CITY OF ST. HELENS PLANNING DEPARTMENT
STAFF REPORT
Site Development Review SDR.9.21
Sign Permit S.9.21

LOCATION: St. Helens High School at 2375 Gable Road

PROPOSAL: Addition and renovation of the existing high school. Includes modification to some parking areas and expansion and addition of outdoor sports facilities in existing open space/athletic fields

Above: image showing the offset between the dedicated right-of-way (ROW) versus the improved roadway of Firlok Park Boulevard.

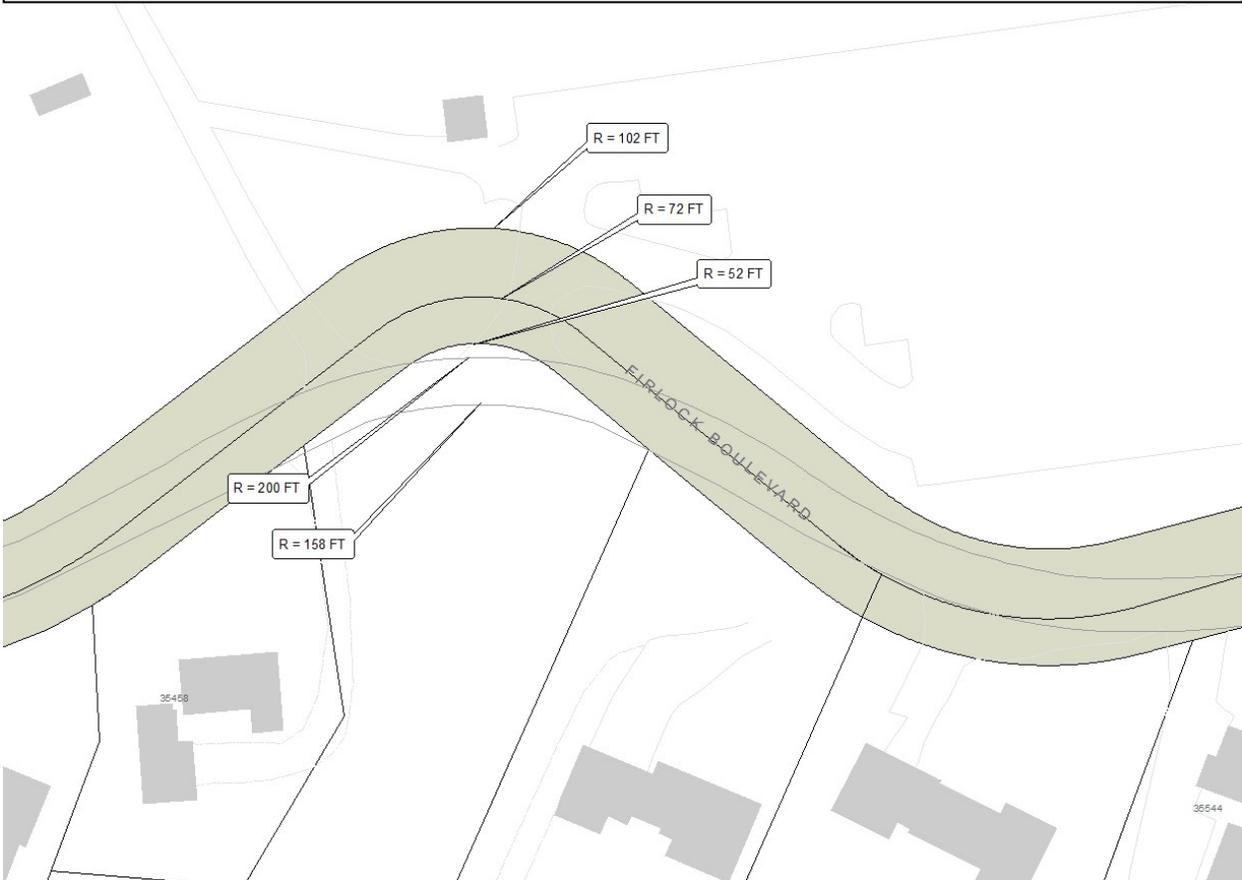
Firlok Park Boulevard is less than the minimum right-of-way (ROW) width. Normally, the requirement for right-of-way dedication would be half of the required width (i.e., 30 from ROW centerline). However, a portion the improved street in relation to the right-of-way appears particularly skewed.

In addition to being skewed, the centerline curve radius of the ROW is less than 100 feet and the paved road itself larger but still well below the normal 500' radius standard for collector streets. For this section, additional right-of-way from the high school property is unlikely needed because road improvements would be less likely to be rebuilt to a lesser curve radius. If 5' was dedicated elsewhere, when Firlok is re-built in the to-be-determined future, there would be more area to straighten the curve out in addition to meeting the standard ROW width requirement.

- vi. Applicant shall provide legal descriptions and a map exhibit from an Oregon Registered Professional Land Surveyor for 5' of right-of-way dedication of Firlok Park Boulevard except at the "skewed area" as described and depicted herein. Professional surveyor shall prepare the legal descriptions in cooperation with the city.
